Safety Recall Campaign

SC314

2022MY  
Niro EV (DE EV)

## SAFETY PLUG REPLACEMENT (SC314)

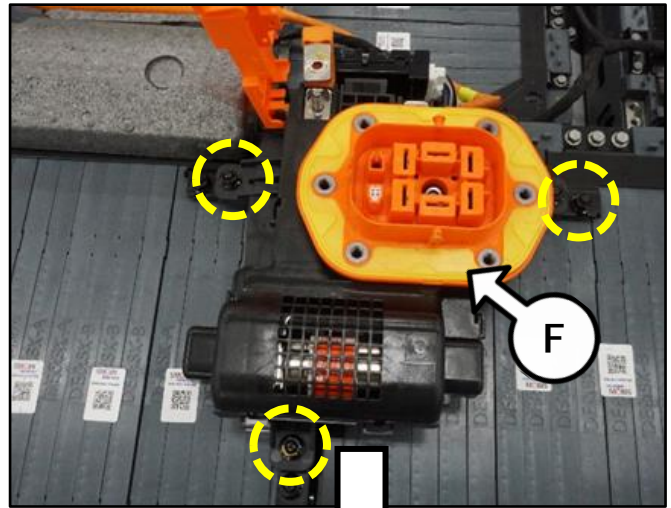
7. Loosen the three (3) nuts to remove and discard the servie plug assembly (F).

8. Install the new safety plug (F).

Tightening torque for Safety Plug Nuts:  
7.2 - 8.7 lb.ft (9.8 - 11.8 N.m)
